**SERVICE LETTER NUMBER 121**

**TITLE: Fuselage modification, Sta. 228, empennage/tail wheel attach bulkhead fastener replacement to facilitate inspection for AD 99-15-07 compliance**

SERVICE LETTER P/N: 1005428 for ECN 10081

Fig. 1 – Doubler shown removed

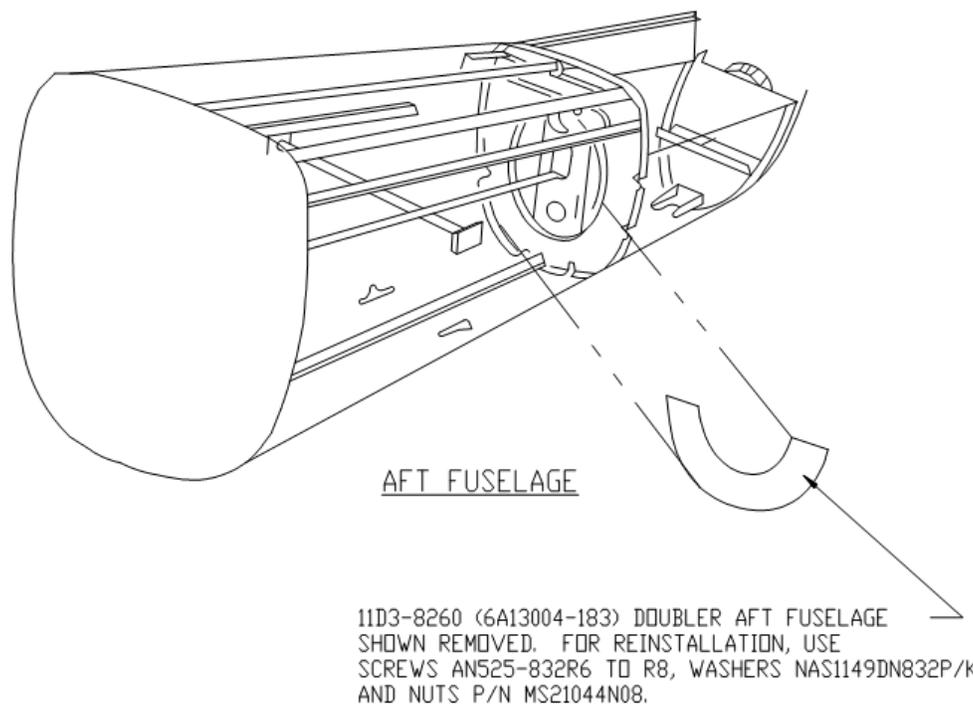
2. Prepare aircraft for access to doubler:
  - a. Remove tail cone
  - b. Remove horizontal tail
3. Drill rivets connecting the forward lower doubler, Wipaire P/N 11D3-8620, to the Sta. 228 bulkhead and aft doubler P/N 11C3-8261. See figure 1 and drawing 11D1-8015

- a. Note: the aft doubler stays in place for this modification – drill only the rivets attaching the forward lower doubler.
4. While the forward lower doubler is removed, accomplish inspection tasks in AD 99-15-07. The Sta. 228 bulkhead is completely visible from the front with the forward lower doubler removed, to allow for inspections operations required by the AD.

6. Reinstall doubler P/N 11D3-8260 with the following hardware; install all hardware wet with epoxy or zinc chromate primer, or Mastinox.. ensure that washers do not interfere with the radius of the bulkhead or aft doubler.
  - a. Screws P/N AN525-832R6 to R8 length
  - b. Washers P/N NAS1148DN832N or K
  - c. Nut, nylon locking, P/N MS21044N08
